Clover Creek Solar Project LLC d/b/a New Frontiers Solar Park
Responses to Siting Board Staff's First Request for Information
Case No. 2024-00253

Request No. 1:

Title
Construction Road Entrances

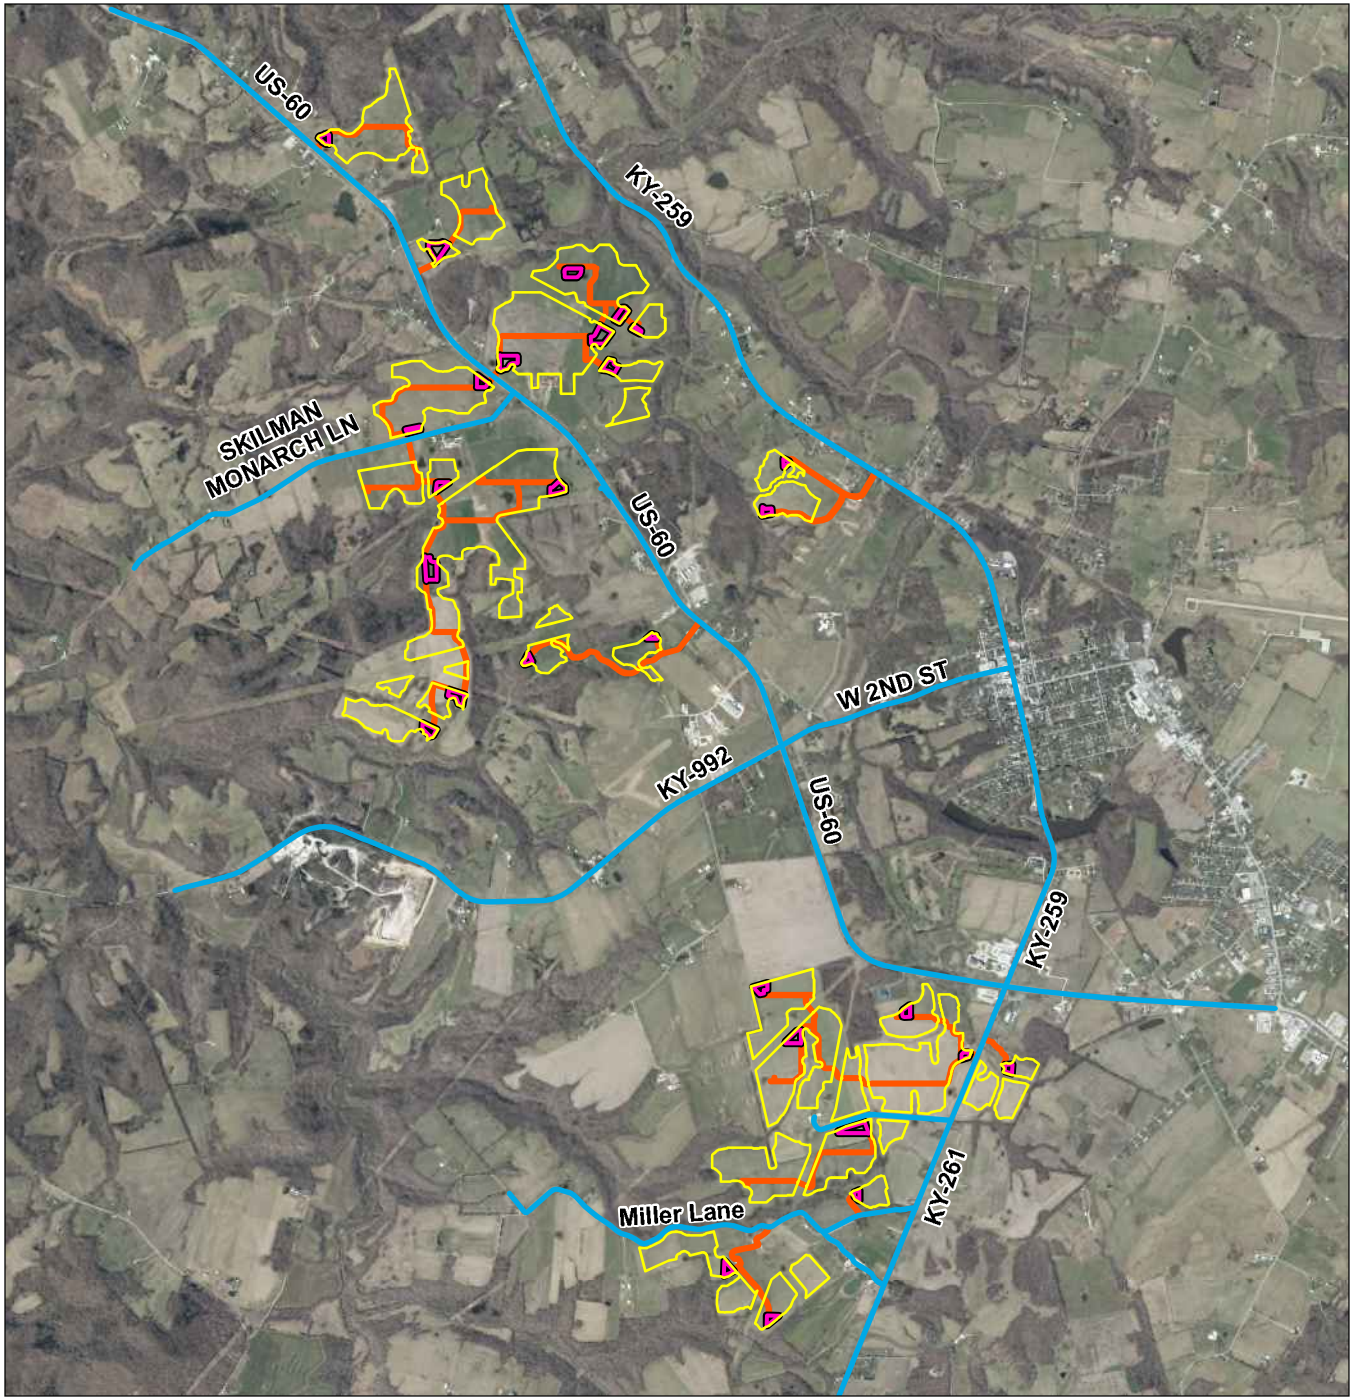
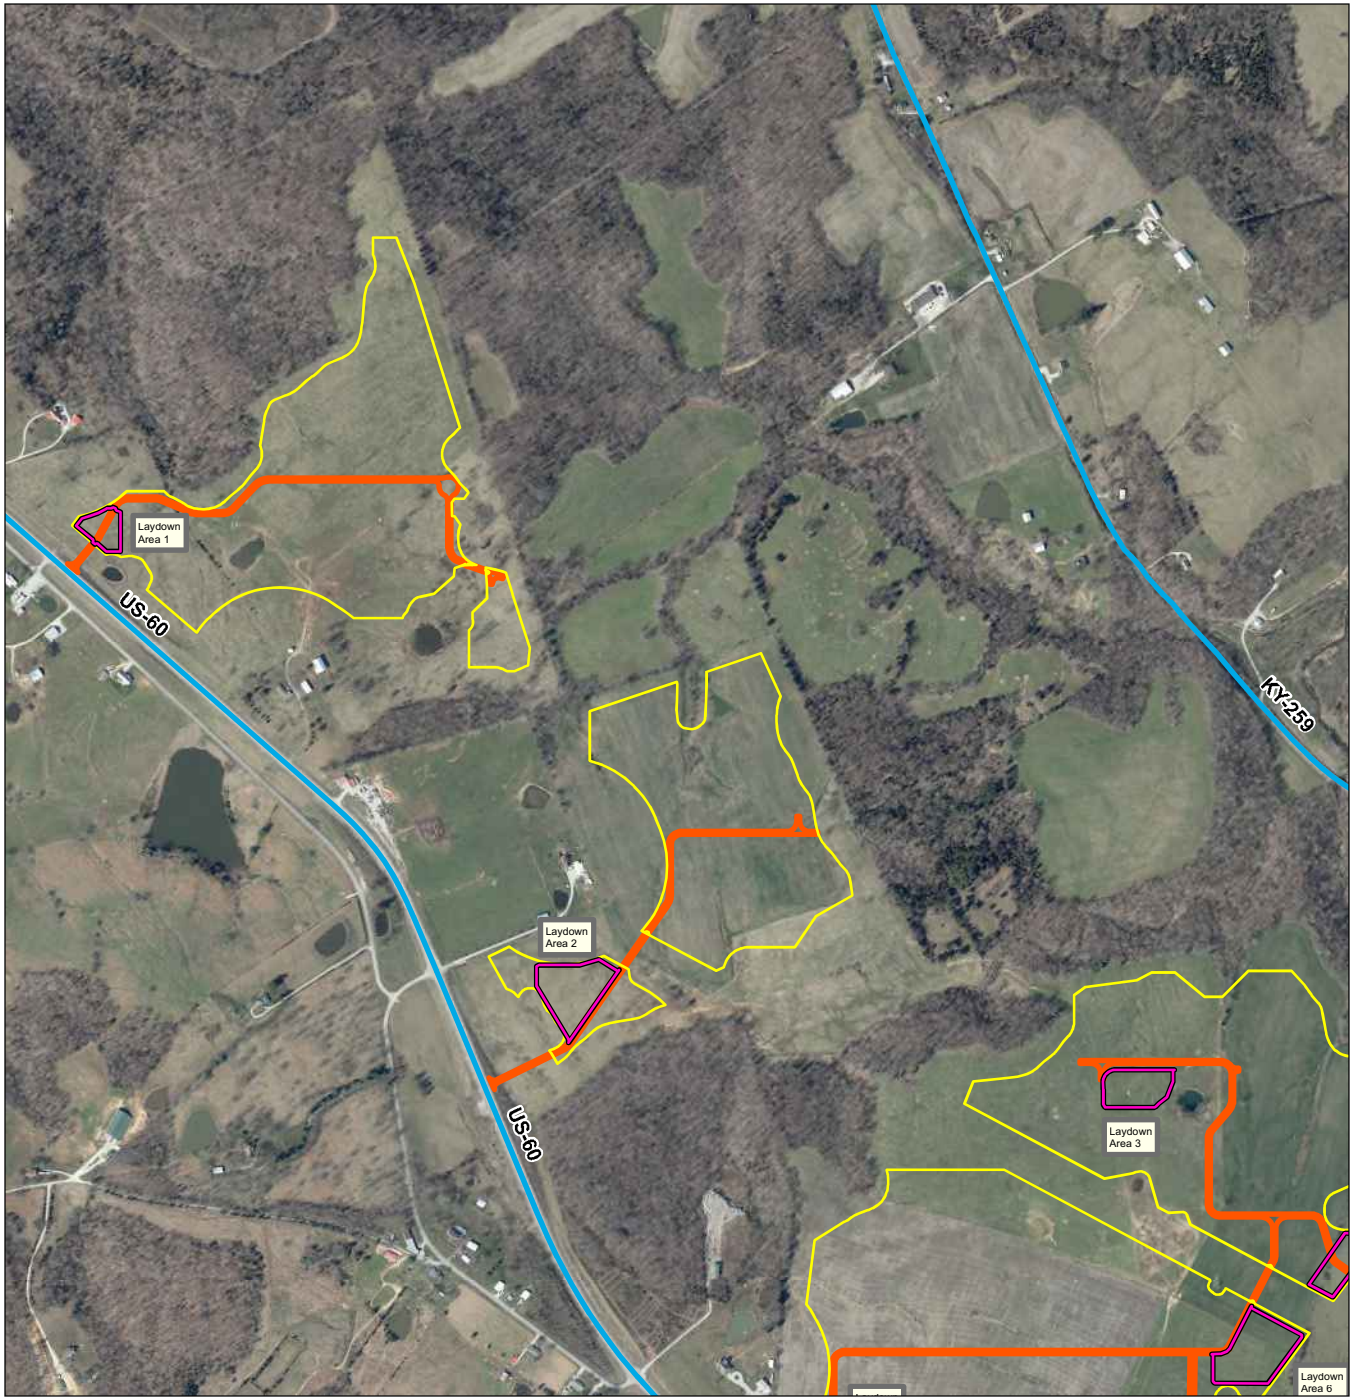
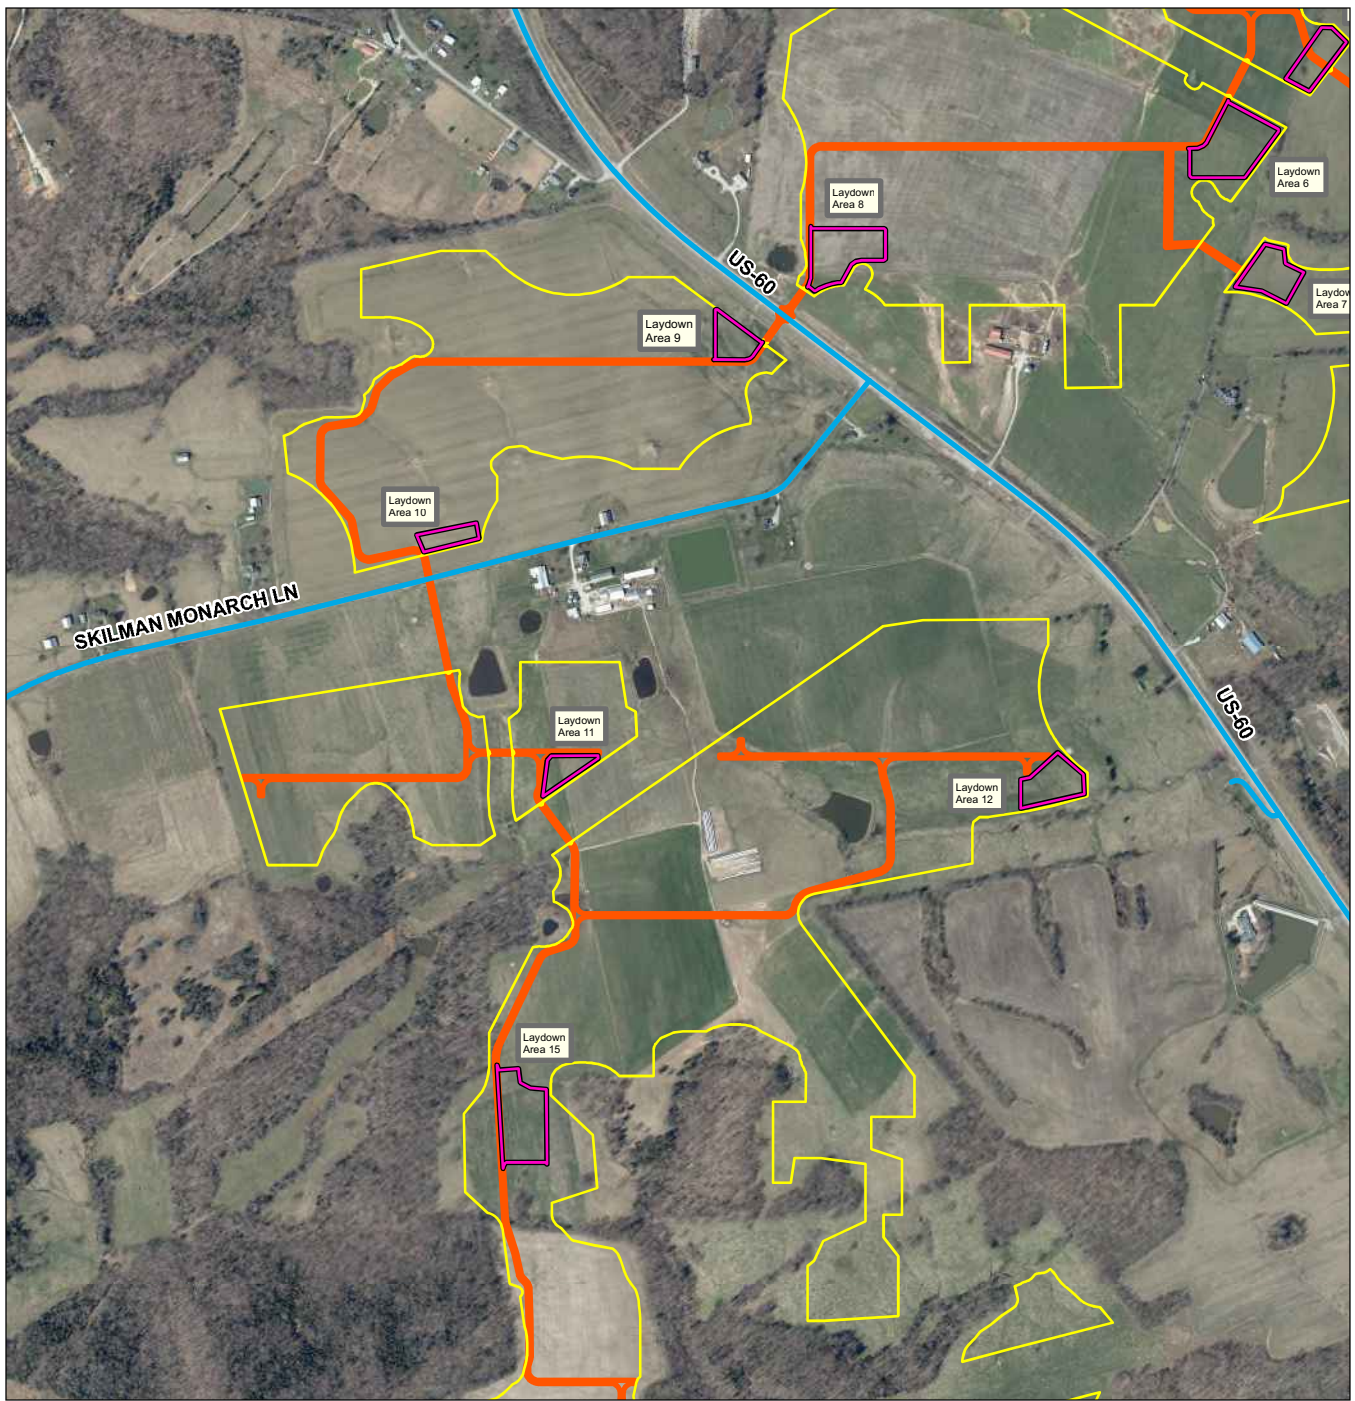
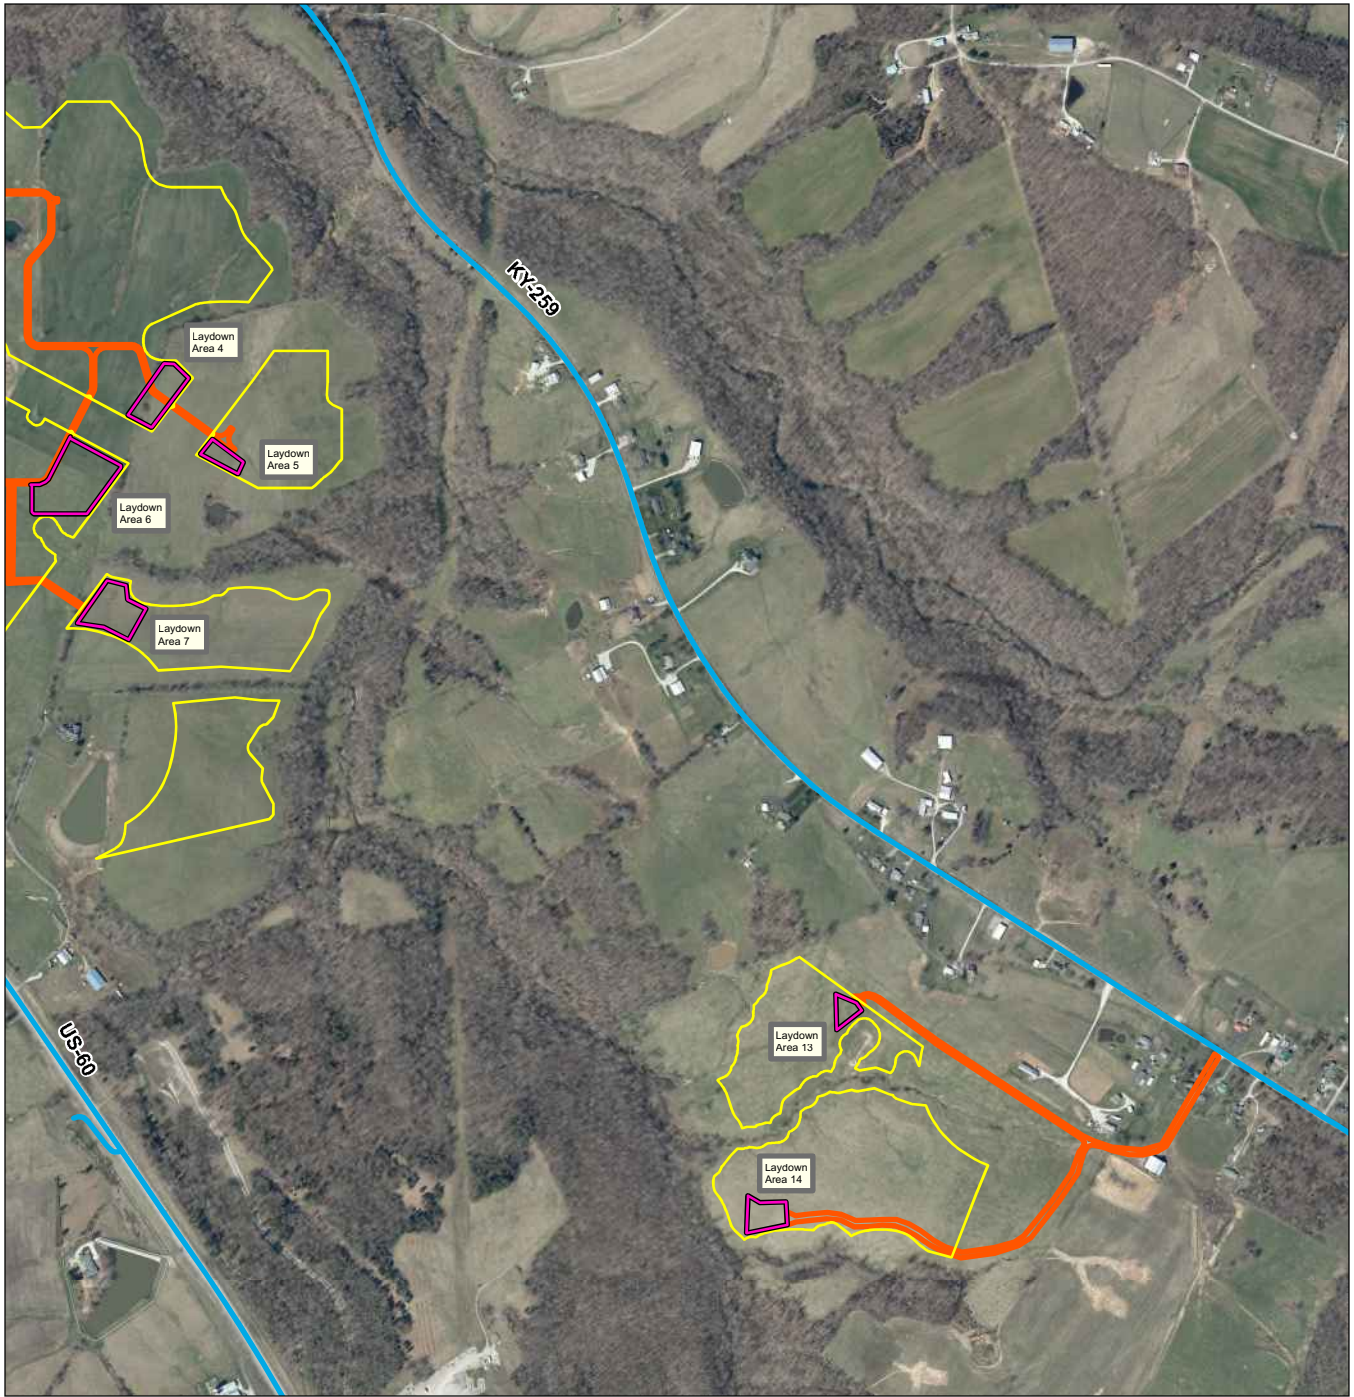
Provide a map highlighting all construction entrances to the Project site and all roads proposed to be used.

Response No. 42:
